Howard County
Health Department

FOR PERCOLATION TESTING AND SITE EVALUATION

RE: Percolation Test Report; 6801 Redberry Road, Clarksville, MD 21029

PLAT TO ACCOMPANY PERC TEST APPLICATION
DOGWOOD, LOT 3, SEC. 1
6801 REDBERRY ROAD
SIDHAY RESIDENCE
TITLE DEED: 14559/354
TAX MAP 35, GRID 19, PARCEL 205
5TH ELECTION DISTRICT, HOWARD COUNTY, MD.
ZONED RR-DEO
SCALE: 1" = 50' DATE: 3/6/2015 REV: 3/24/2015

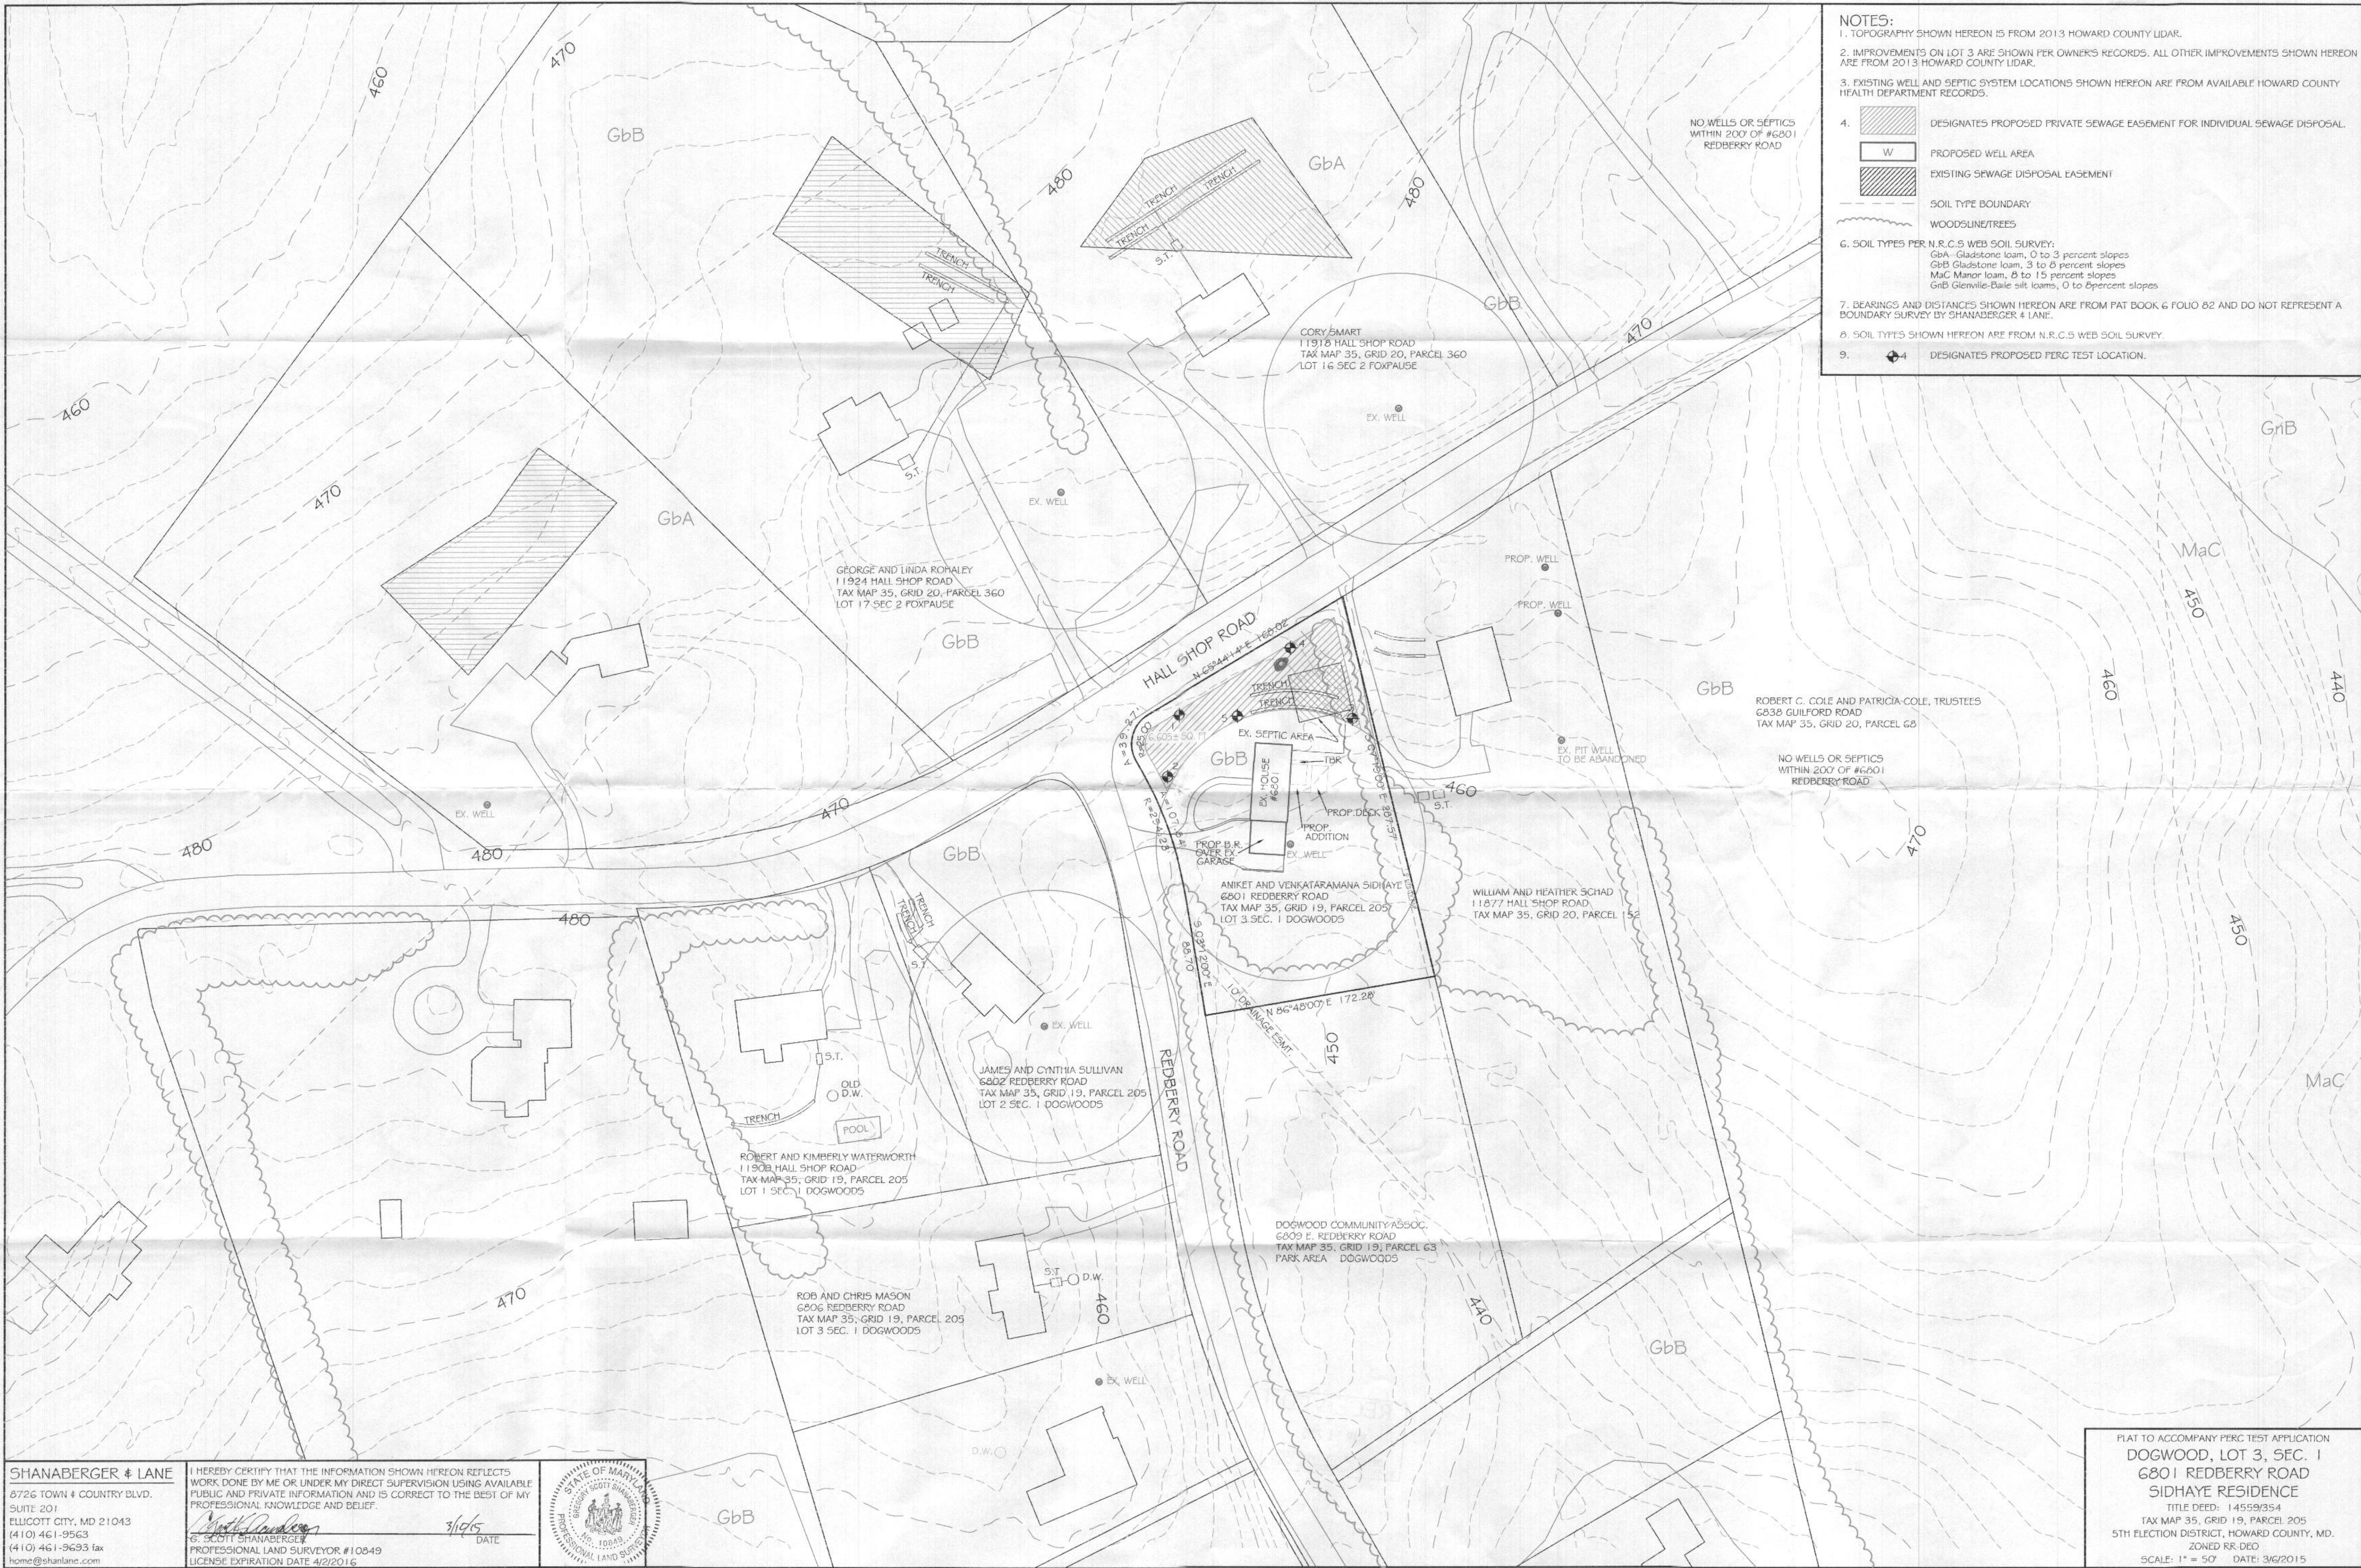
Percolation test holes 2, 6, 7, and 9 **failed** due to high ground water levels. Water seepage was observed at depths as shallow as 3.7 feet down to 6.5 feet. The percolation rate for hole # 6 was less than 2 minutes. Since these test holes failed, this office cannot approve the proposed sewage disposal area on this percolation plan.

With that said, the areas in the vicinity of holes 6 and 9 may be suitable for a non-conventional sand mound system for a repair should you need a replacement system in the future.

Prior to scheduling the next phase of testing, we will need to see this information on a revised plan showing the exact location of the existing septic system. If the system is not located in the proposed sand mound locations, and the existing septic system does not meet the 4 foot buffer requirement then we may proceed with At-Grade or Sand Mound testing.

Also, the Sand Mound calculations submitted for review shows a Bed Length of 80 feet but the length of the proposed sand Mound systems shown on the plan are only 65 feet.

The existing well is only 100 feet from the proposed septic area. Under local code, a down gradient well needs to be at least 200 feet from a septic system. The well will have to be moved to the back side of the property.

Thank you for your inquiry about **6801 Redberry Road**. You mentioned that you were interested in assisting the homeowners with their project. Based on the perc testing conducted on April 22, 2015, the outcome was shallow water at the highest part of the yard which indicated that the existing system is likely not adequate (doesn't meet the current 4 foot buffer requirement) and there's no room for even one conventional system for a repair (should the homeowners need it).

The updated drawing needs to show two sand mound locations missing the existing trench plus the BAT upgrade.
